From: Lewark, Chris
Sent: Thursday, January 14, 2021 2:22 PM
To: blake.yazel <blake.yazel@lonestarsv.com>
Subject: REMA charger inlet cable update

TSB – Rema Charge Inlet Quality Issue

From: Ziehm, Dan <dan.ziehm@dana.com>
Sent: Friday, January 15, 2021 7:29 AM
To: Bob Kern; Wayne Wilson; Crystal Childress
Subject: TSB for Rema Inlet Issue
Attachments: TSB_REMA_Inlet_issue_PACCAR_14_01_2020.pdf

TSB – Rema Charge Inlet Quality Issue

Fig 2 – Cros sectional view of wire + cutting tool

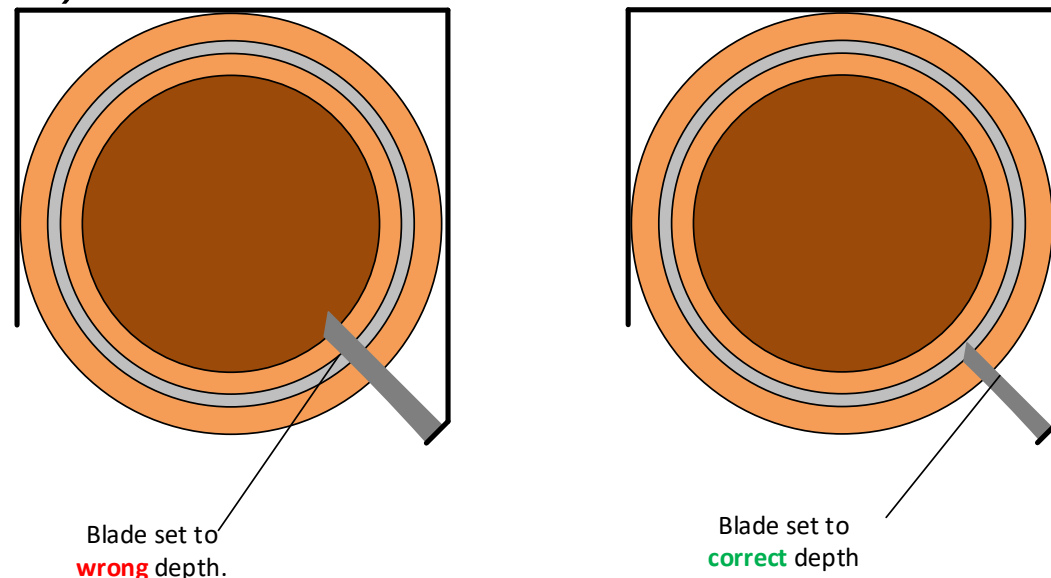
During manufacturing by Rema, two layers (1+2) of the cable are removed near the charge inlet and covered in shrink tube. Due to the tooling used, there is a high-risk of cutting through the inner layers (3+4).

Fig 1 – Cross Sectional view of shielded cable

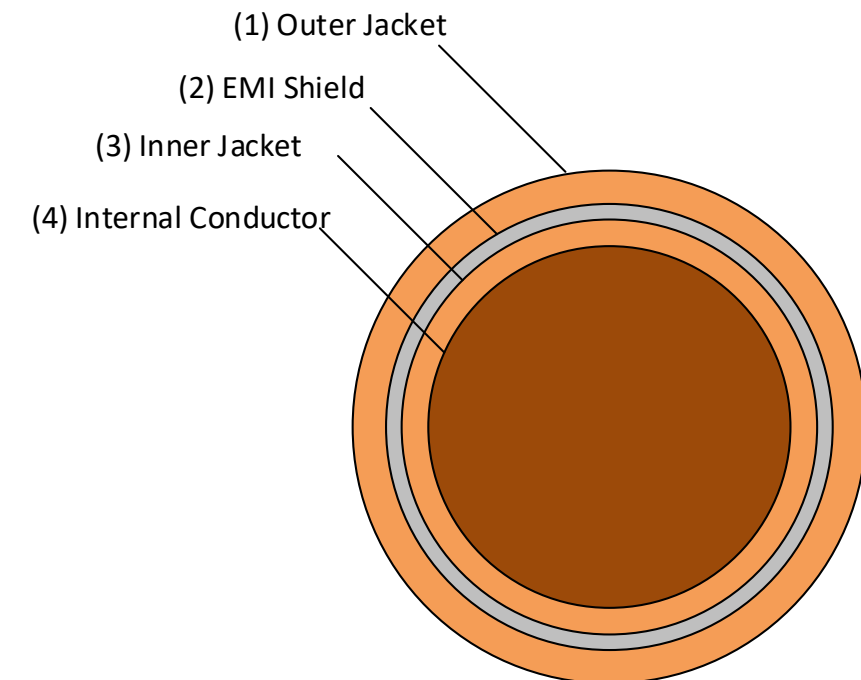
A manufacturing quality issue was identified with the Rema AC/DC Charge Inlet (P/N 9602094 (1741-002-01)). The supplier identified a manufacturing issue by which improper tooling and inadequate inspection of their assembly may lead to exposed and cut HV wiring jacket and conductors within the charge inlet assembly; and, inadequate adhesion of a piece of shrink tubing may expose a portion of the shield.

Fig 3 – Inner conductor + Inner Jacket cut

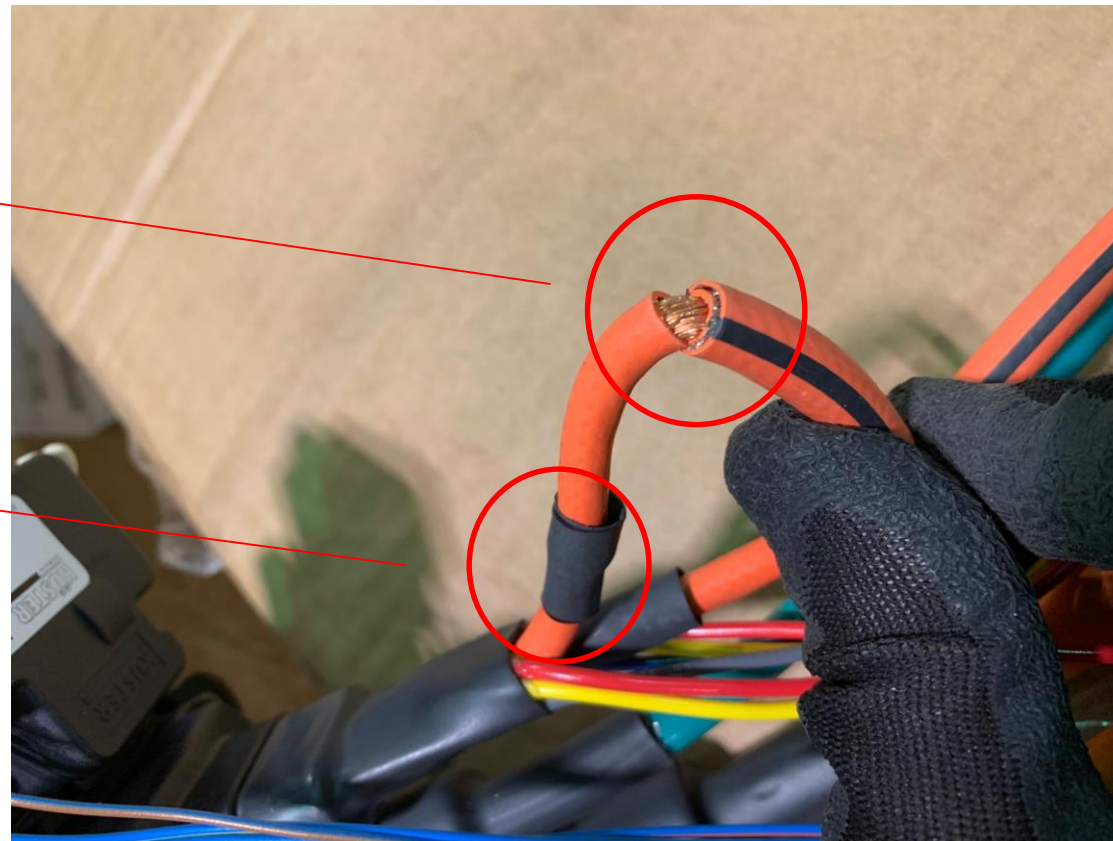
The issue was discovered due to shrink tubing that was not adhering to the cable assembly.

Shrink tubing not adhering to cable

Fig 4 – Inner Jacket cut, conductor not exposed

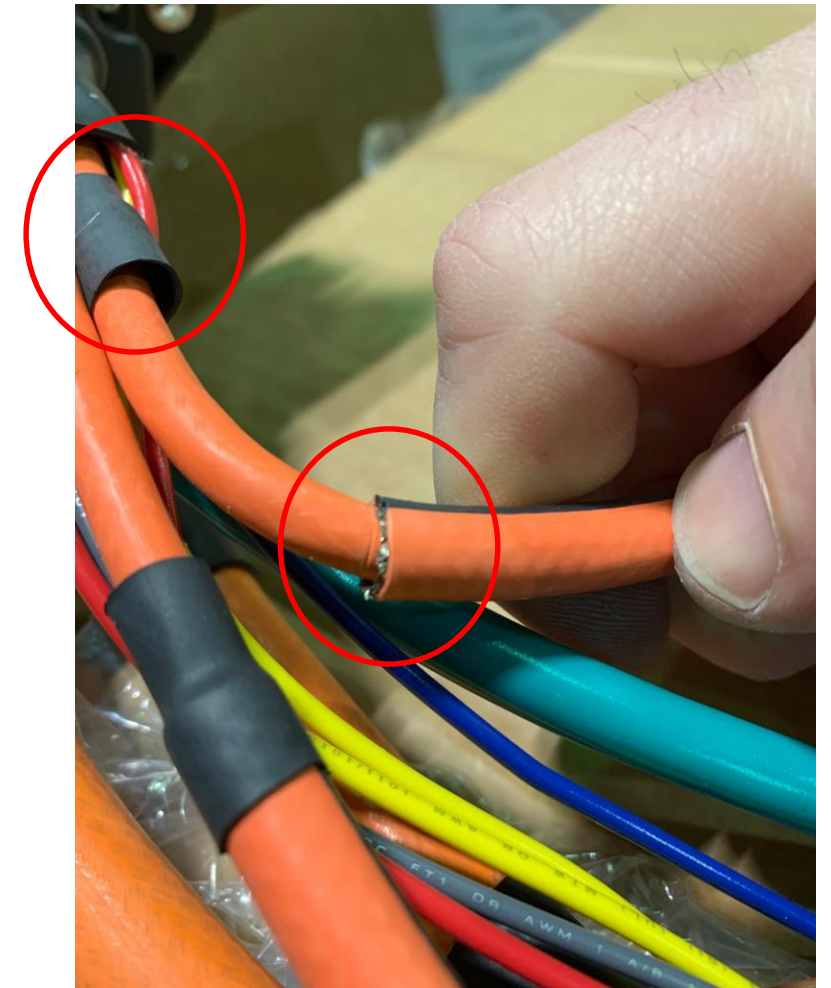
Cut inner jacket without exposed conductor

Fig 2 – Cross sectional view of wire + cutting tool

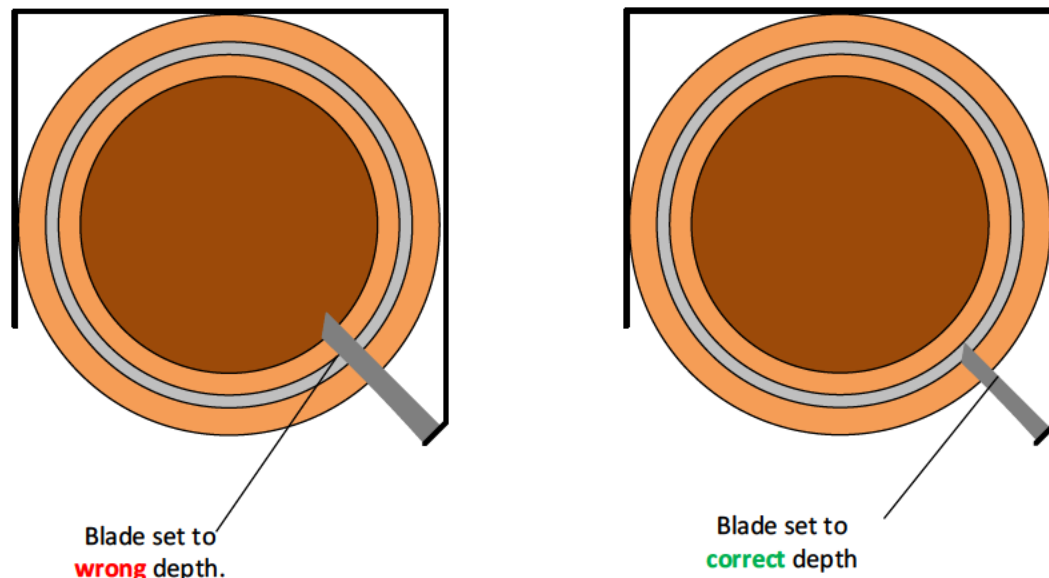
During manufacturing by Rema, two layers (1+2) of the cable are removed near the charge inlet and covered in shrink tube. Due to the tooling used, there is a high-risk of cutting through the inner layers of the cable, exposing the conductor (3+4).

Fig 1 – Cross Sectional view of shielded cable

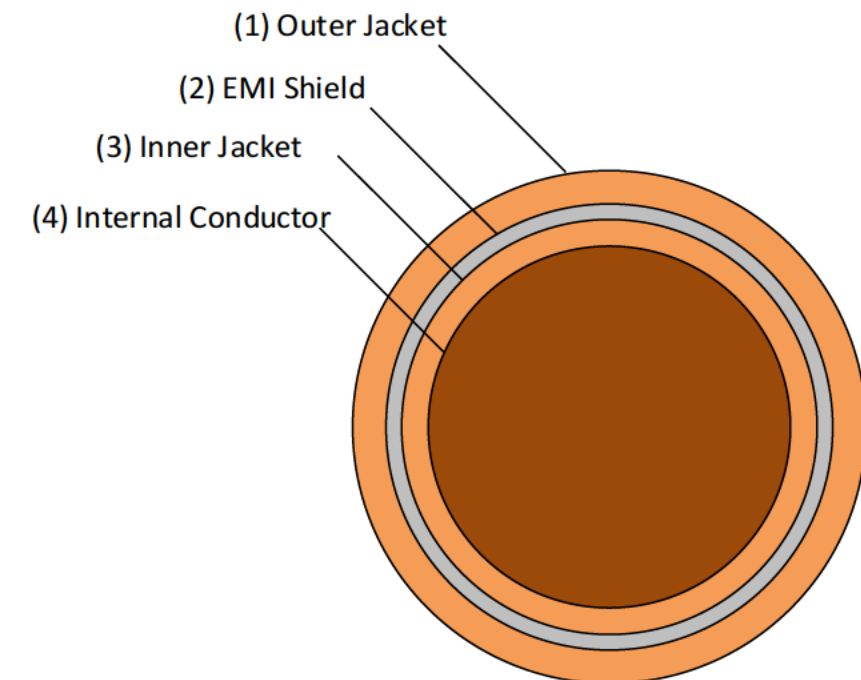
A manufacturing quality issue was identified with the Rema AC/DC Charge Inlet (P/N 9602062 (1741-008-00)). The supplier identified a manufacturing issue by which improper tooling and inadequate inspection of their assembly may lead to exposed and cut HV wiring jacket and conductors within the charge inlet assembly; and, inadequate adhesion of a piece of shrink tubing may expose a portion of the shield.

Fig 3 – Inner conductor + Inner Jacket cut

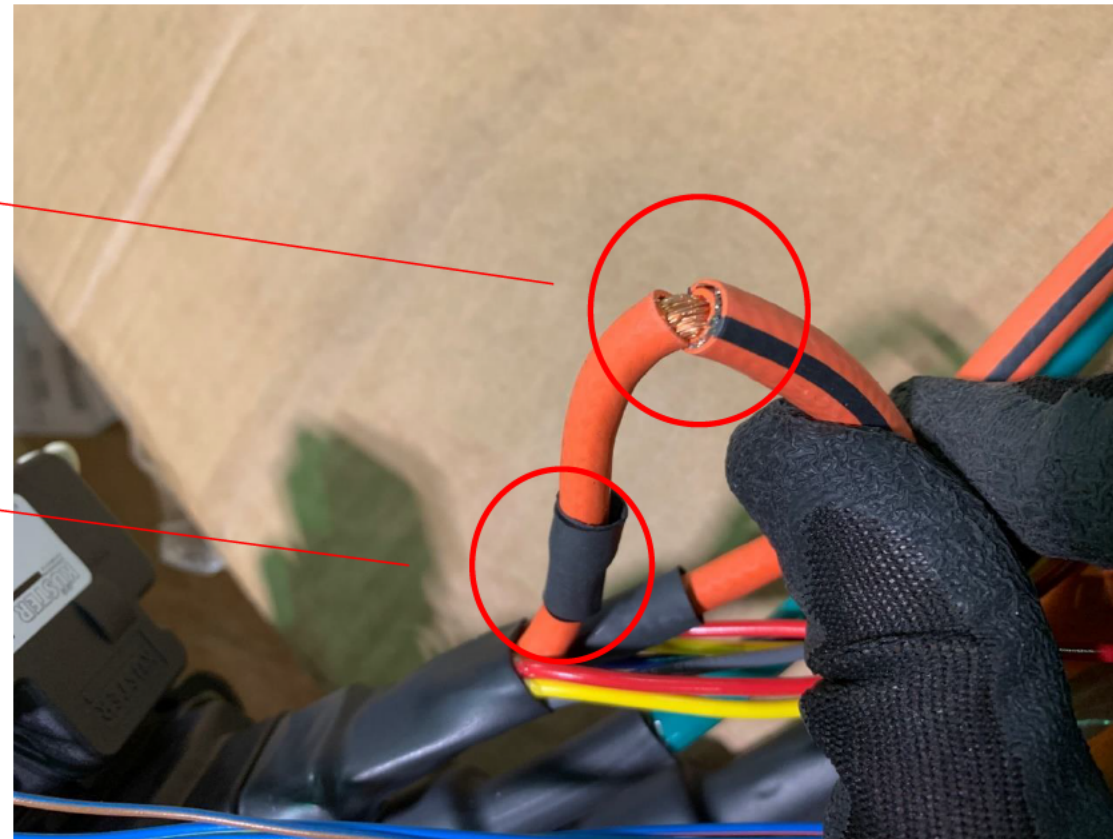
Dana inspected the stock on hand in its facility.

Shrink tubing not adhering to cable

Fig 4 – Inner Jacket cut, conductor not exposed

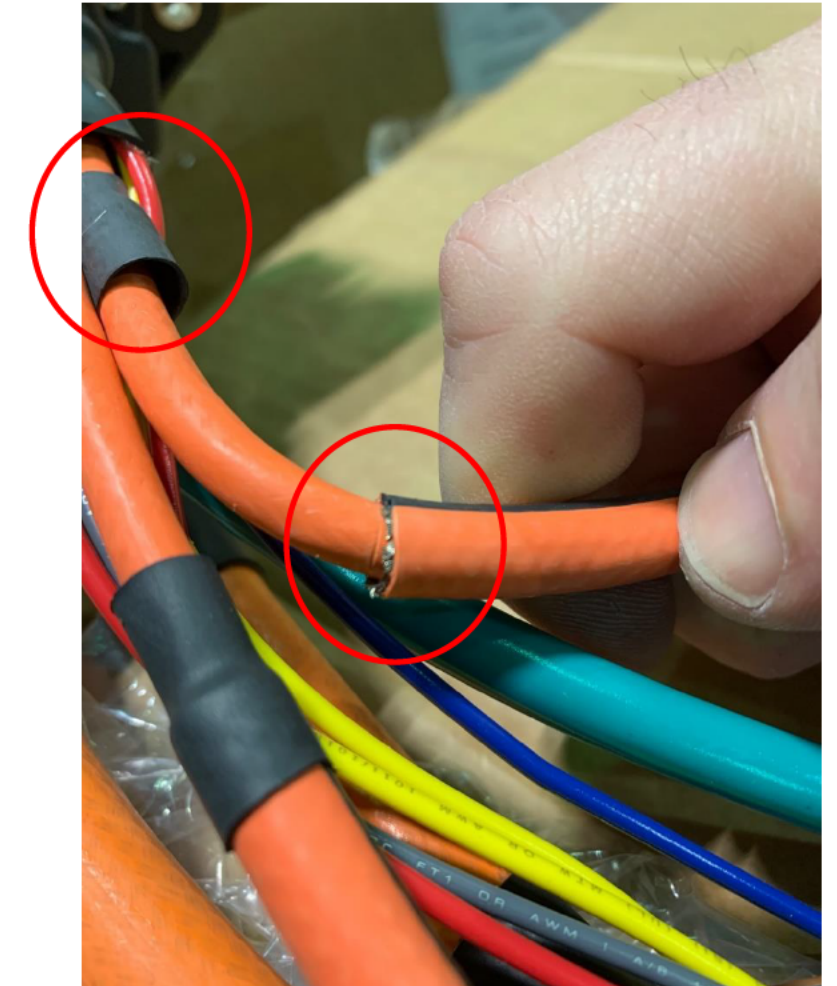
Cut inner jacket without exposed conductor
